**Large-Scale Residential Development (LRD) Opinion
Planning and Development Act 2000 (as amended)
Planning and Development Regulations 2001 (as amended)**

**RE: LRD25-03
Greenfield, Ballincollig.**

Cork City Council
 Planning and Integrated Development Directorate
 LRD Opinion Meeting Minutes Ref: LRD25-03

Re. MAGLIN LRD Greenfield LRD – Opinion Report
Planning Ref. LRD25-03
Date: 27 May 2025

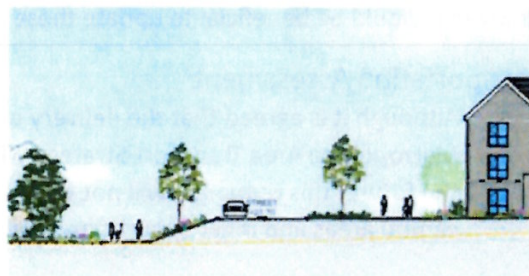
site focusing connectivity both internally and externally within the site. I have the following connectivity issues to be addressed in the next design iteration.

- Short Additional footpath south of 1001
- New Footpath opposite 4015 (on the other side of the road)
- New Footpath opposite 4001-4006 (on the other side of the road)
- Short Additional footpath west of 1090
- Extend Active travel route to the west of the Creche, remove route through the bike store
- Extend Active Travel Route to the north of the bike store (Creche)
- Convert active travel route in front of Block 1 and Block 2 to just a footpath.
- Provide a footpath between the creche and its neighbouring parking
